# NORTH TEXAS MUNICIPAL WATER DISTRICT

## LAKE SIDE INTERCEPTOR REPLACEMENT

PROJECT NO. SRWWPCF 07-1(102)

### CONFORMED SET

**NORTH TEXAS MUNICIPAL WATER DISTRICT**  
 LAKESIDE INTERCEPTOR REPLACEMENT  
 PLAN AND PROFILE  
 STA. 24+00 TO STA. 29+00

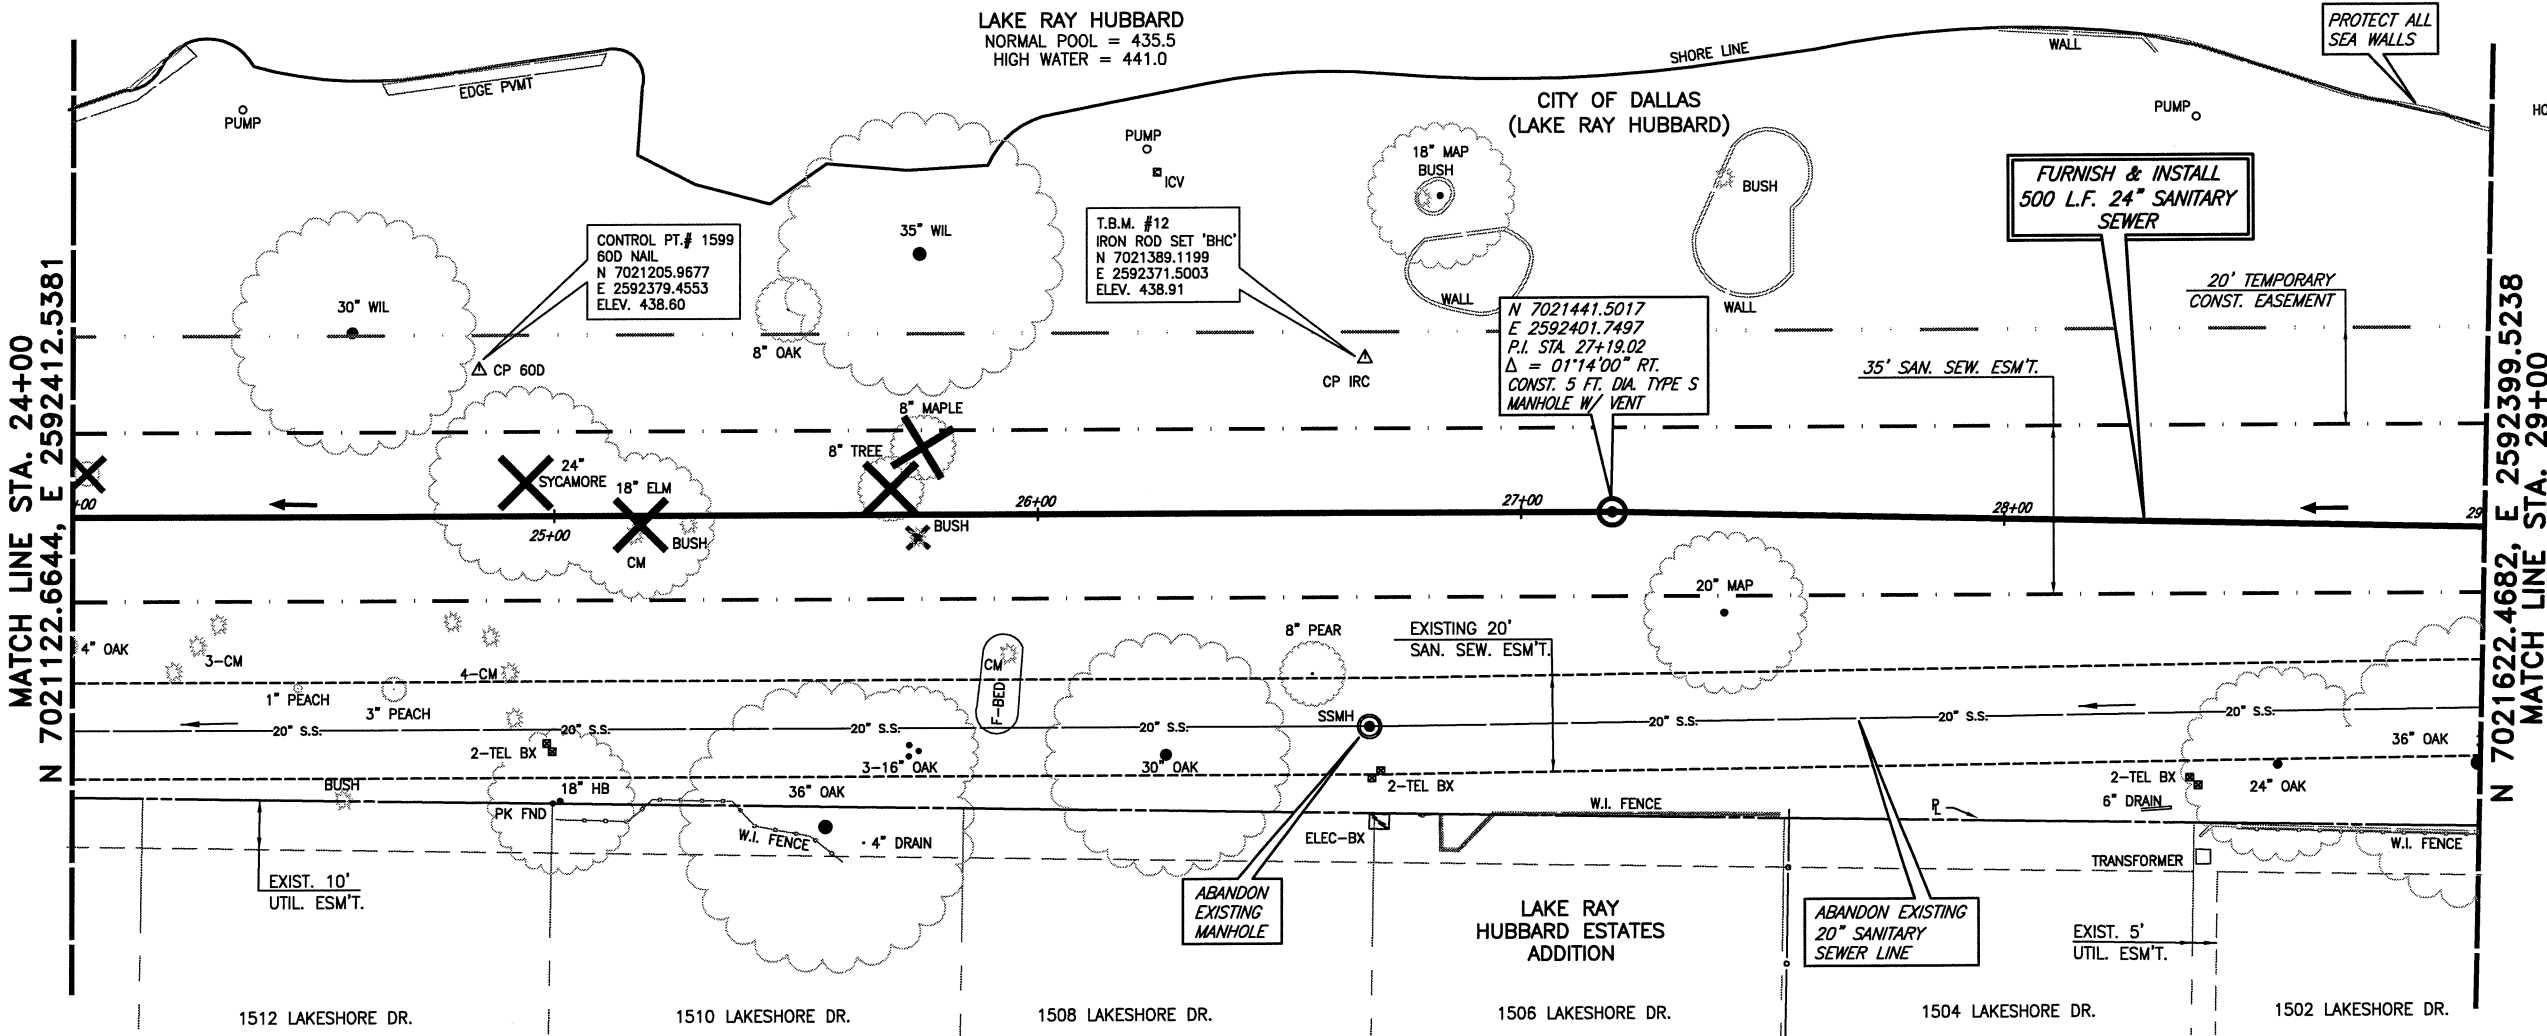
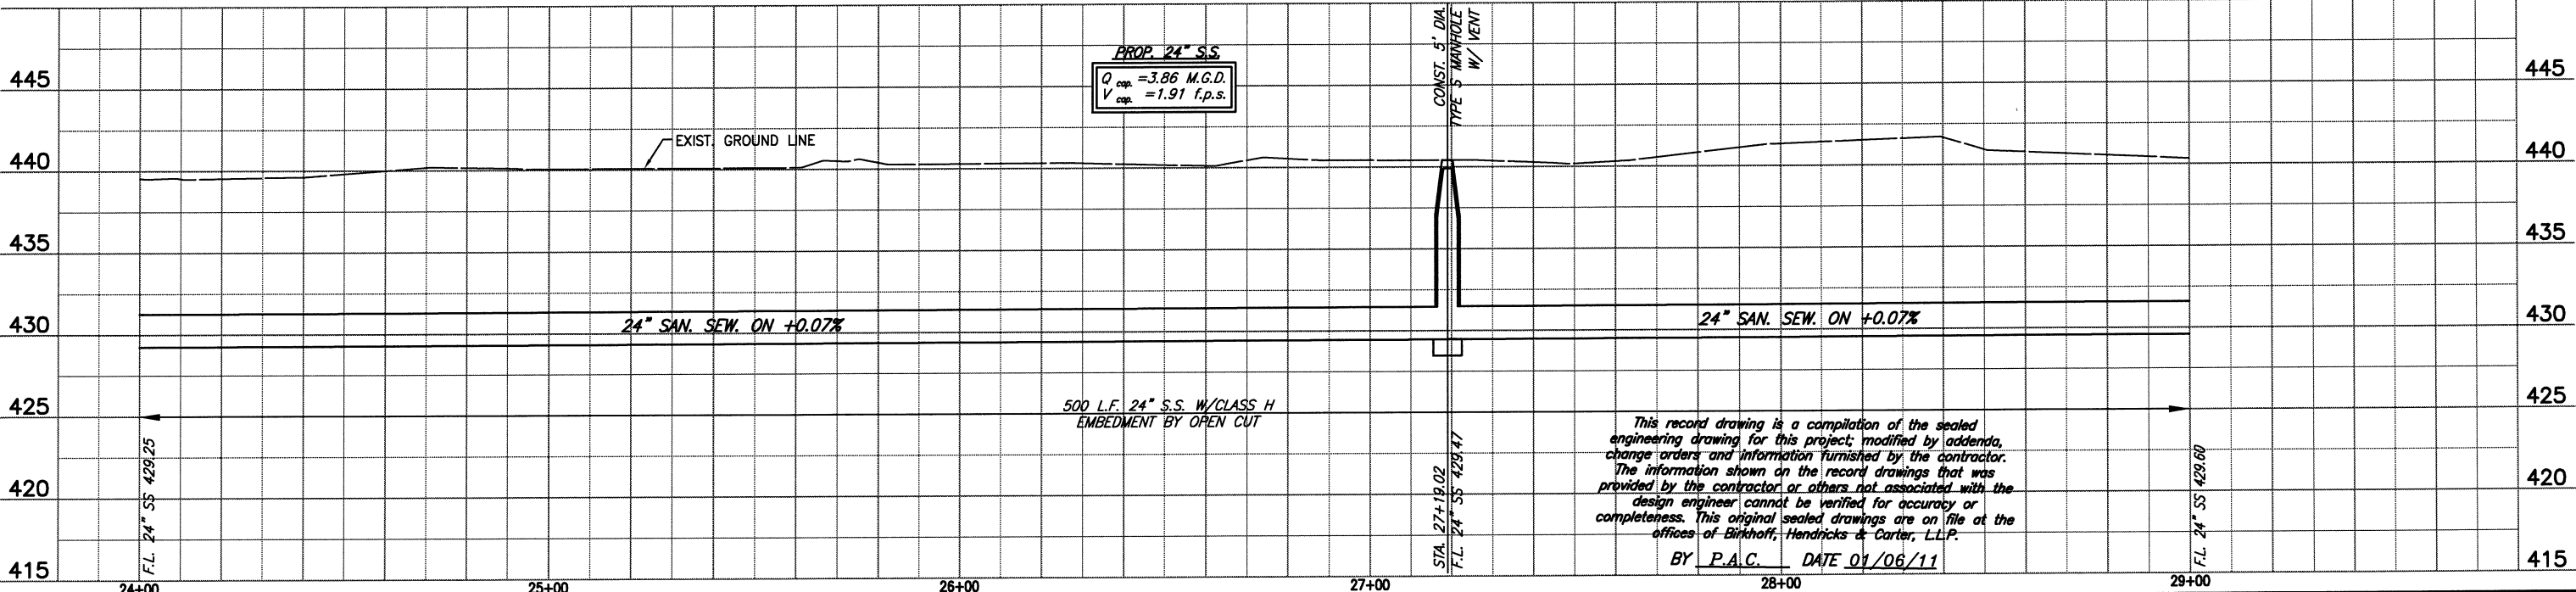
FIELD CHANGE NO.2	2/12/09	REVISED TREE REMOVAL LOCATIONS
FIELD CHANGE NO.2	2/12/09	REVISED BORE LOCATIONS & ENCASEMENT
FIELD CHANGE NO.4	6/29/09	REVISED VERTICAL ALIGNMENT

**PLAN AND PROFILE**  
 STA. 29+00 TO STA. 34+00

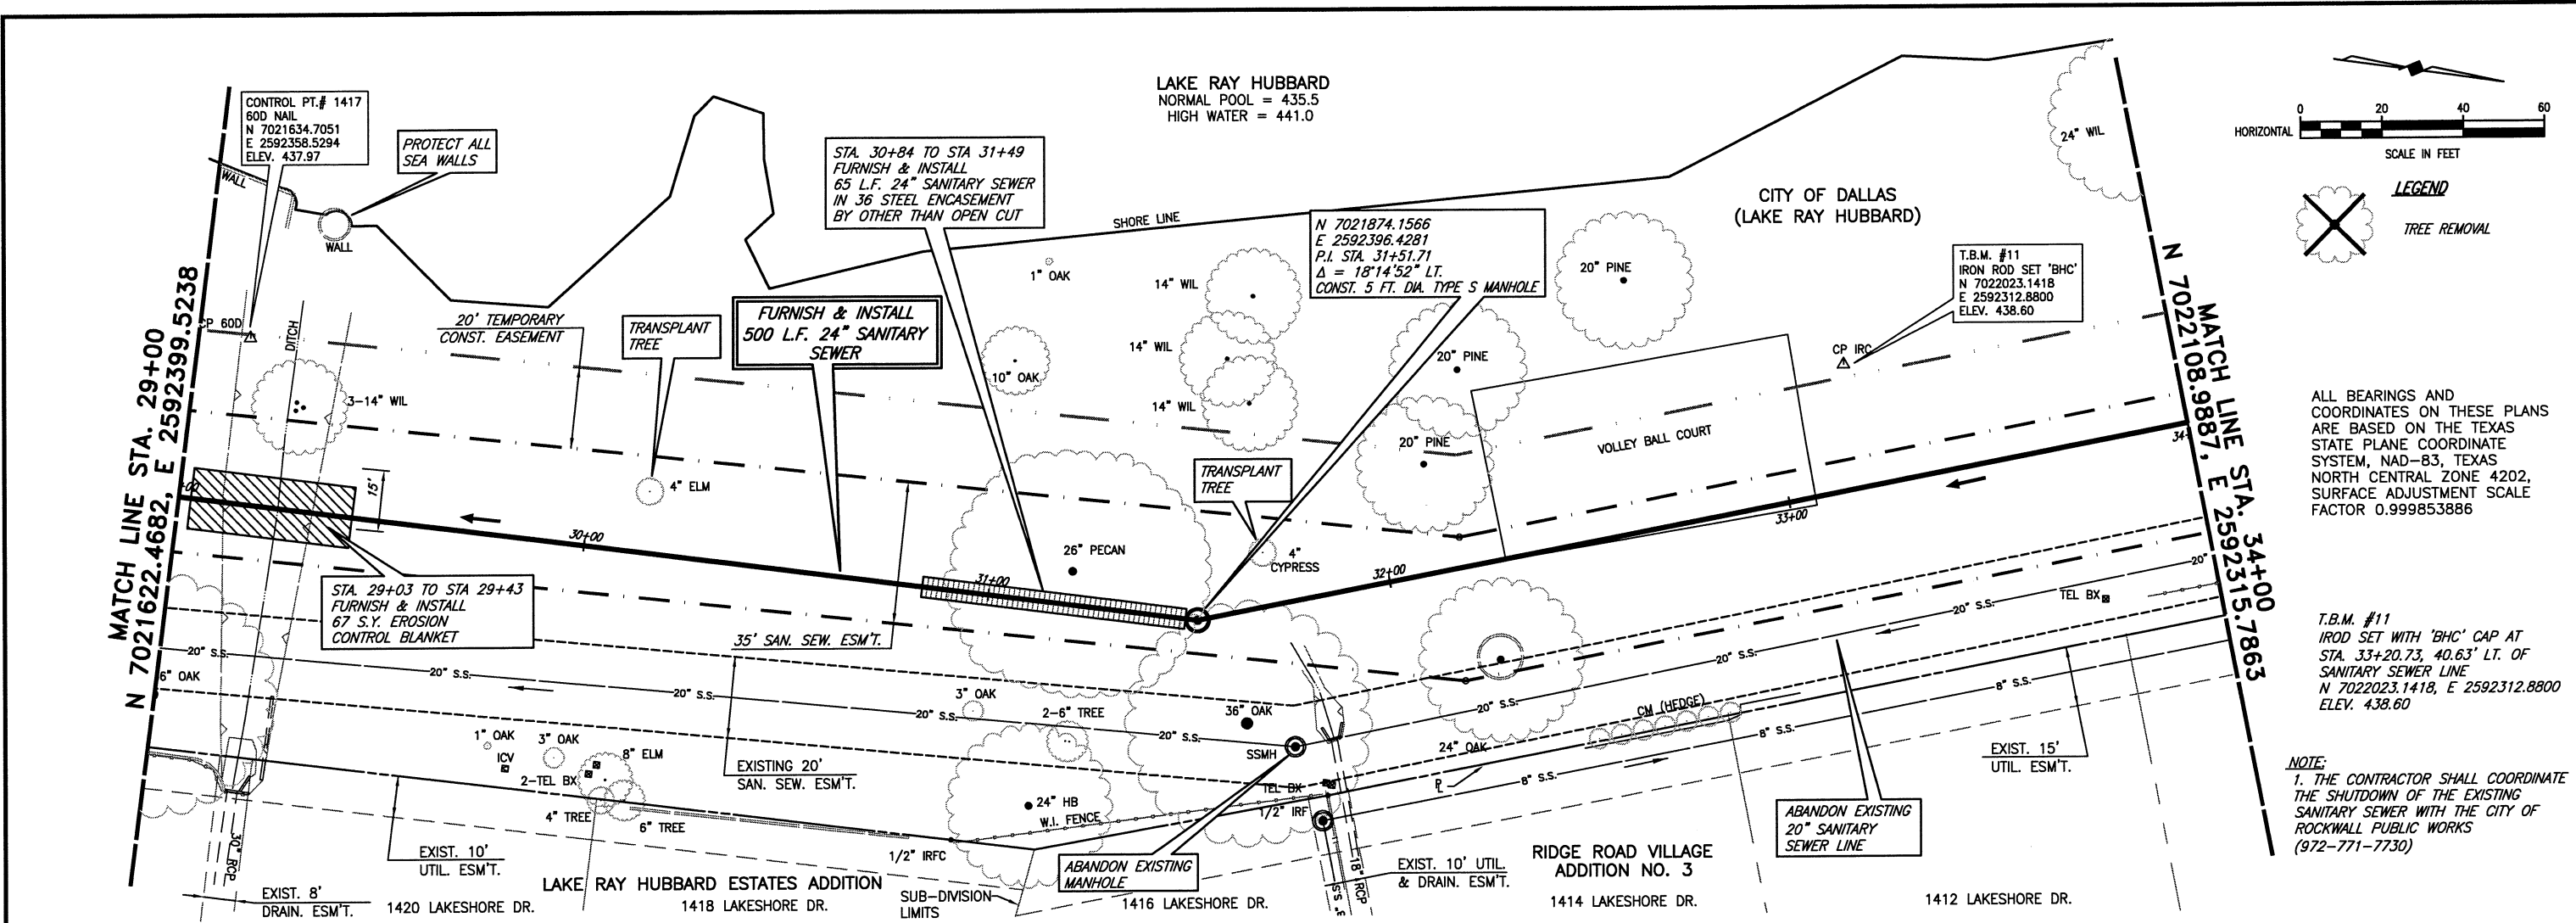
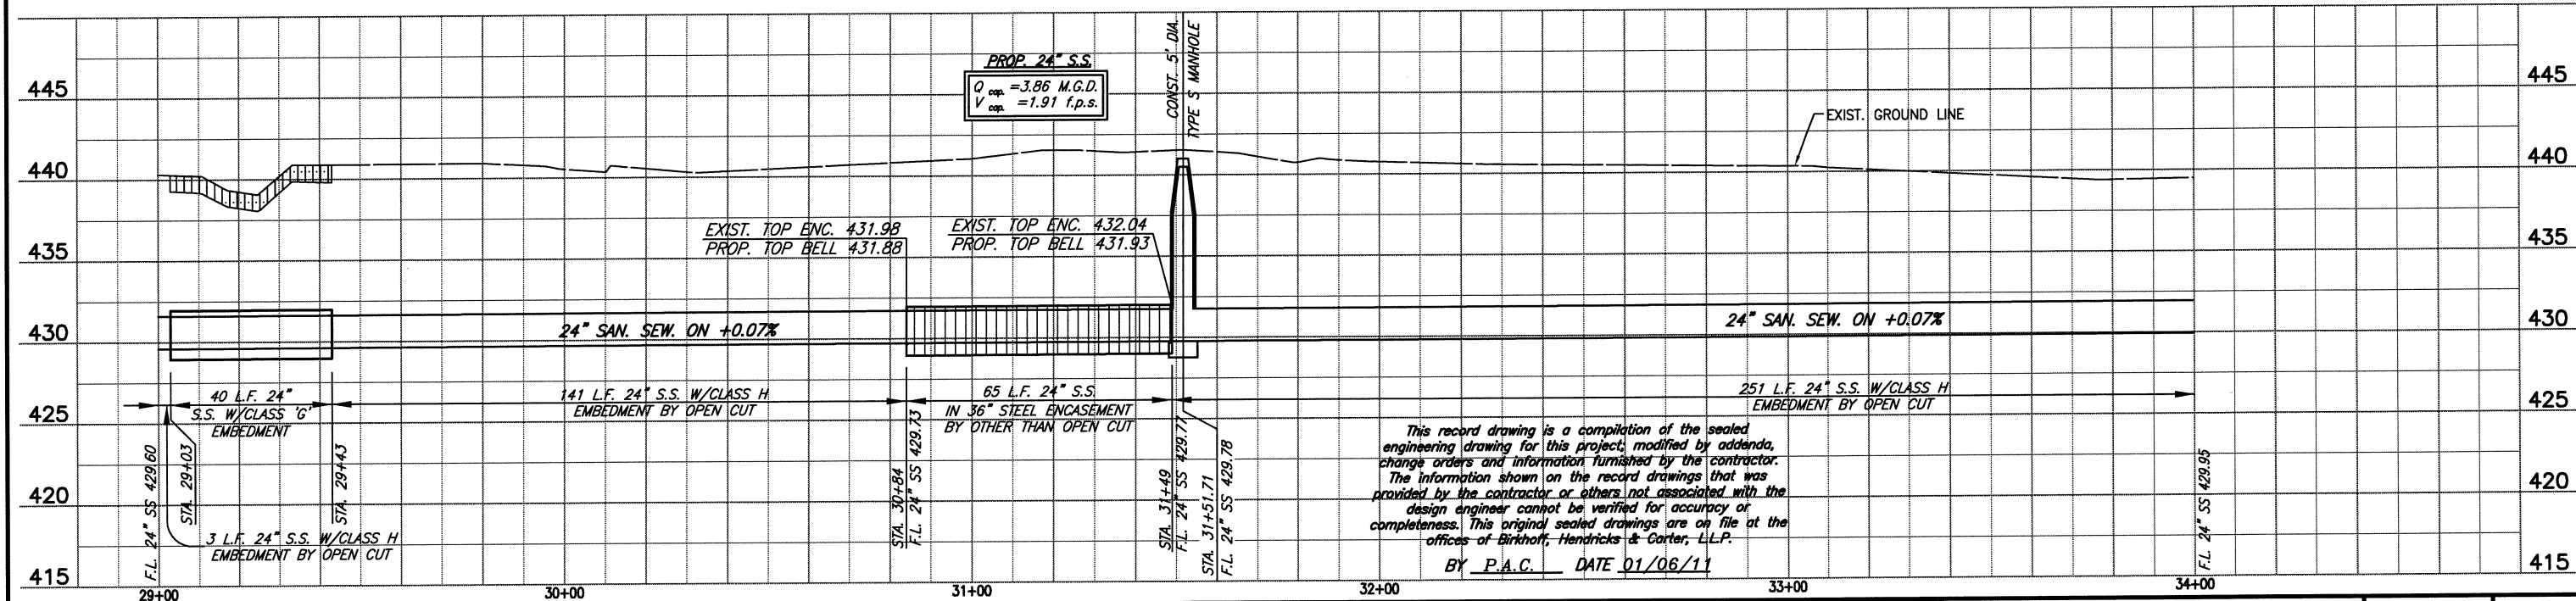
△	FIELD CHANGE NO.2	2/12/09	- REVISED TREE REMOVAL LOCATIONS
①	CHANGE ORDER NO.1	2/12/09	- REVISED BORE LOCATIONS & ENCASEMENT
△	FIELD CHANGE NO.4	6/29/09	- REVISED VERTICAL ALIGNMENT
